**RE: Rocky Mountain Stone- Addition
4741 Pan American Frwy. NE
Grading & Drainage Plan
Engineer's Stamp Date: 03/14/24
Hydrology File: F16D019**

Based upon the information provided in your submittal received 03/14/2024, the Grading & Drainage Plan is approved for Building Permit and Grading Permit. Please attach a copy of this approved plan in the construction sets for Building Permit processing along with a copy of this letter.

C-101

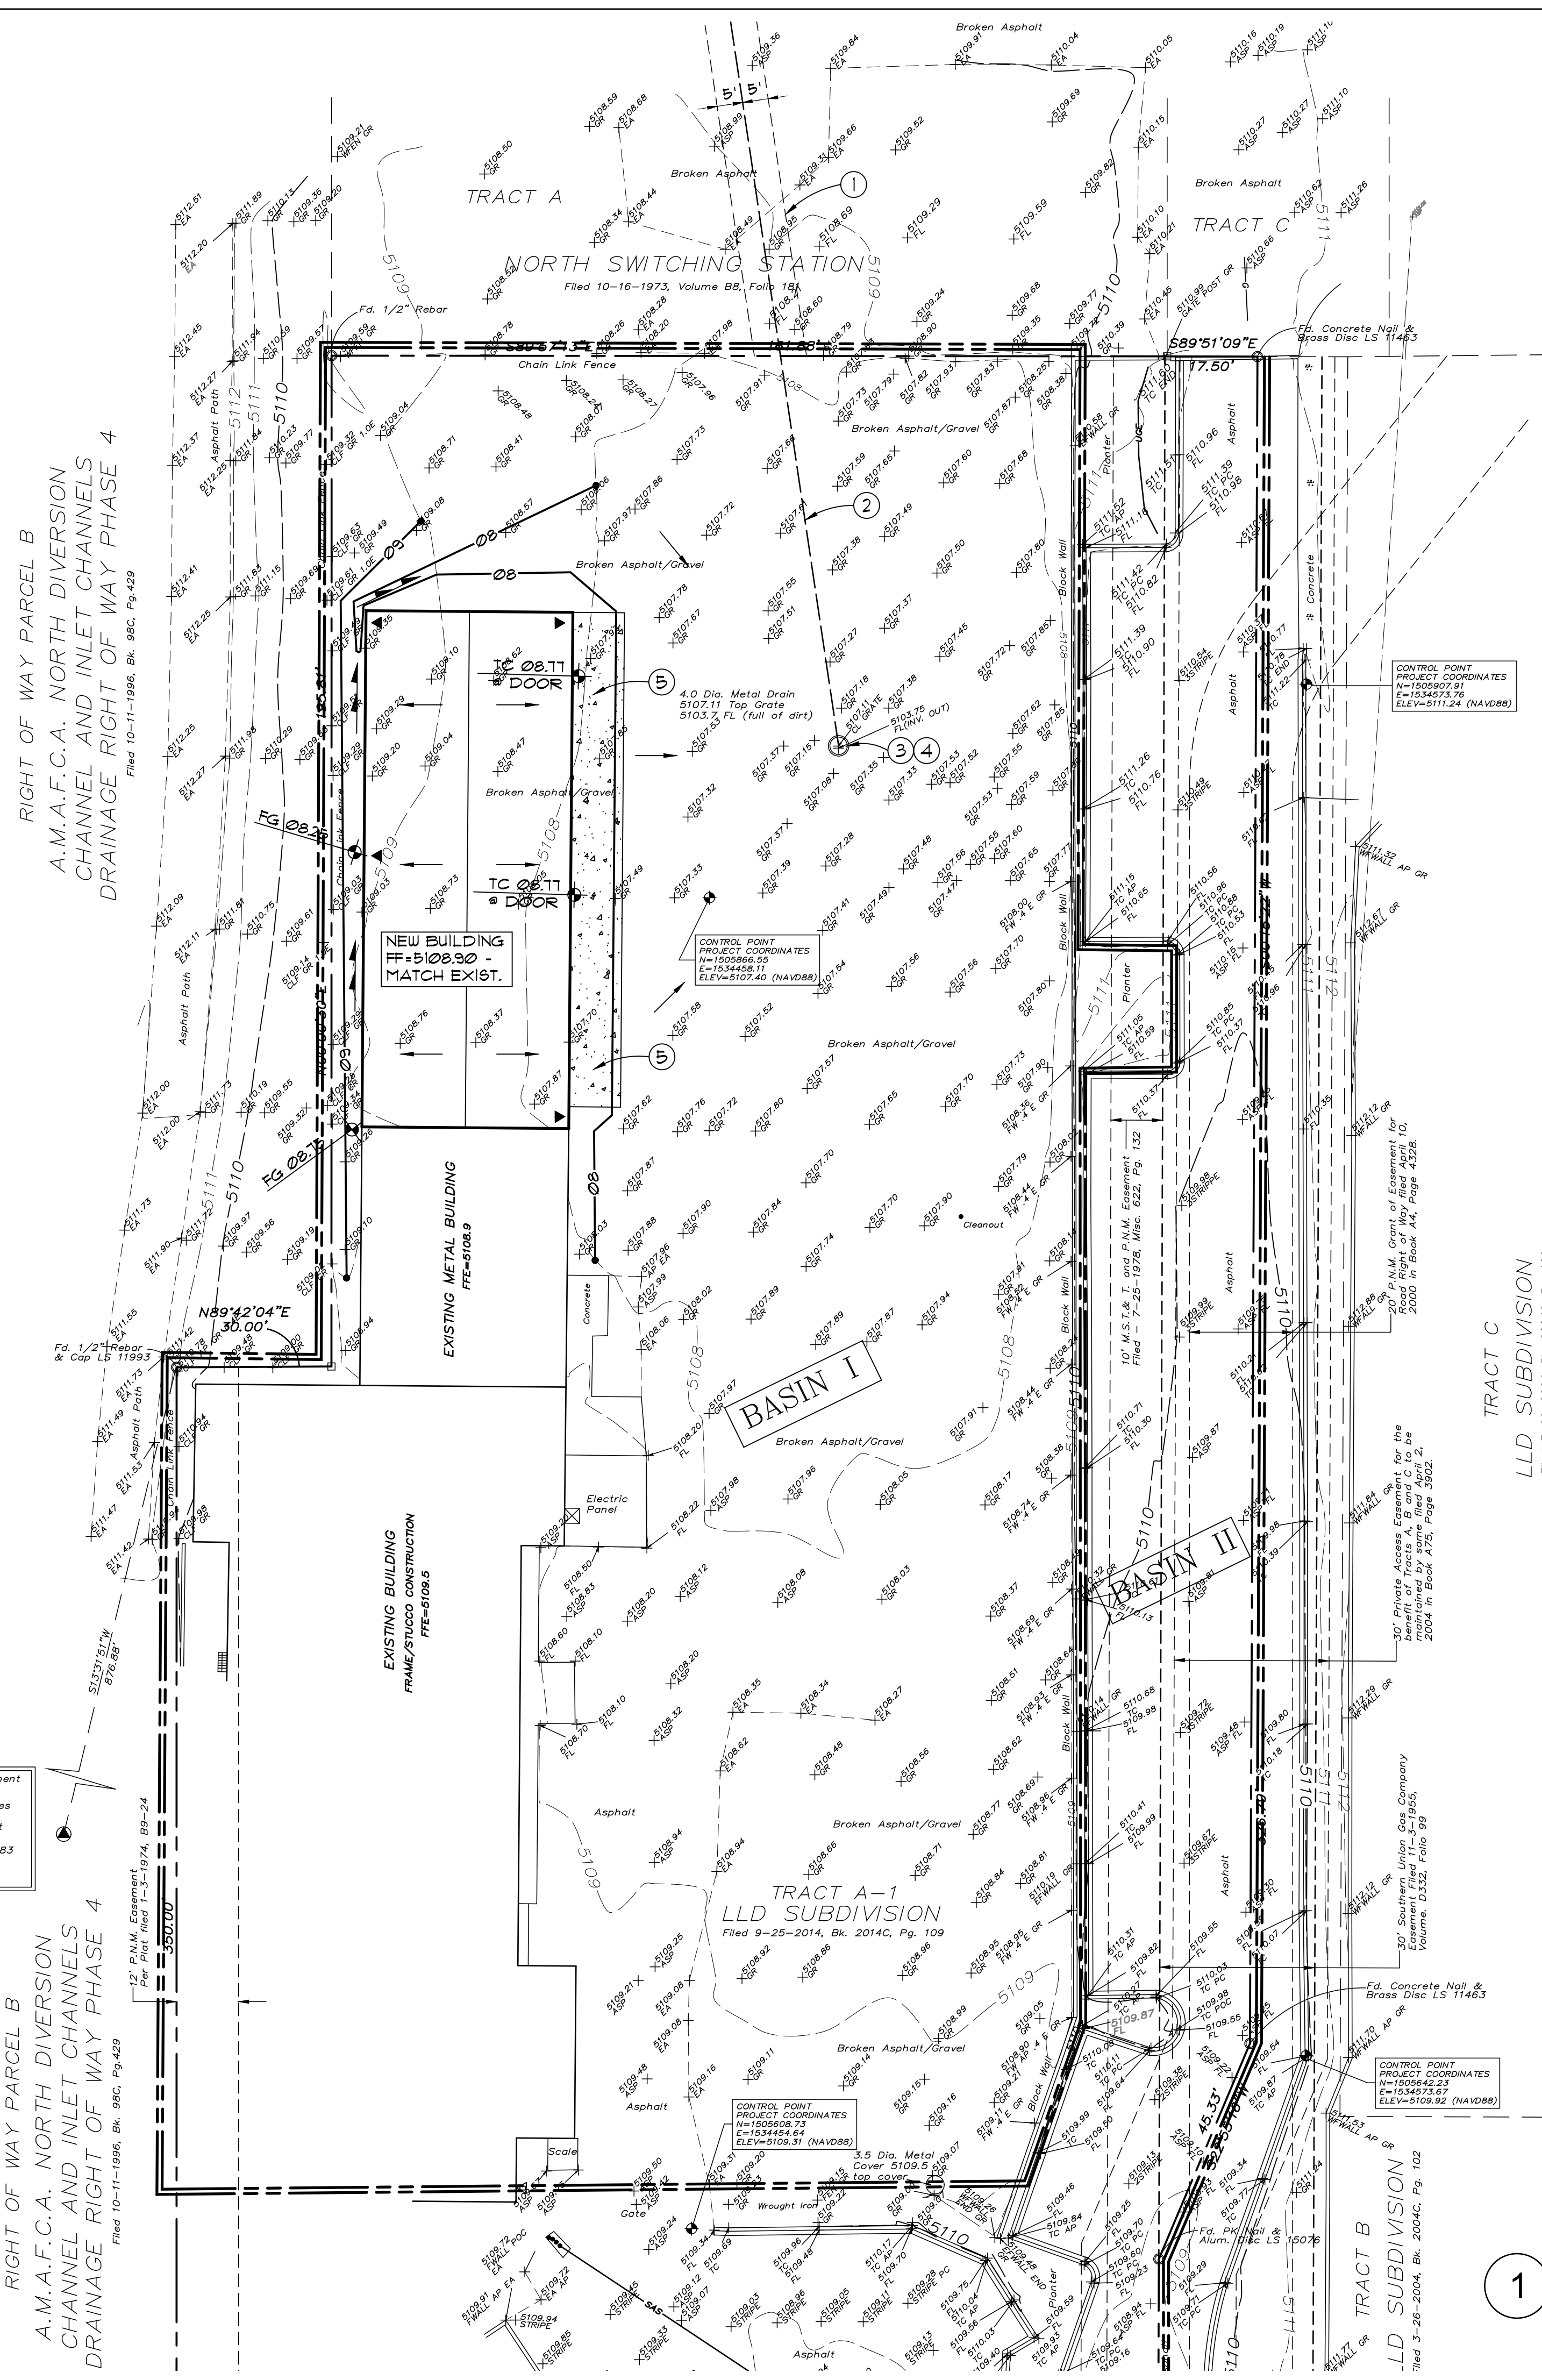
1. Engineer's Certification, per the DPM Part 6-14 (F): *Engineer's Certification Checklist For Non-Subdivision* is required.
2. Please provide the executed paper Drainage Covenant (latest revision) printed on one-side only with Exhibit A and a check for **\$25.00** made out to "**Bernalillo County**" for the stormwater quality ponds per Article 6-15(C) of the DPM to Hydrology for review at Plaza de Sol.
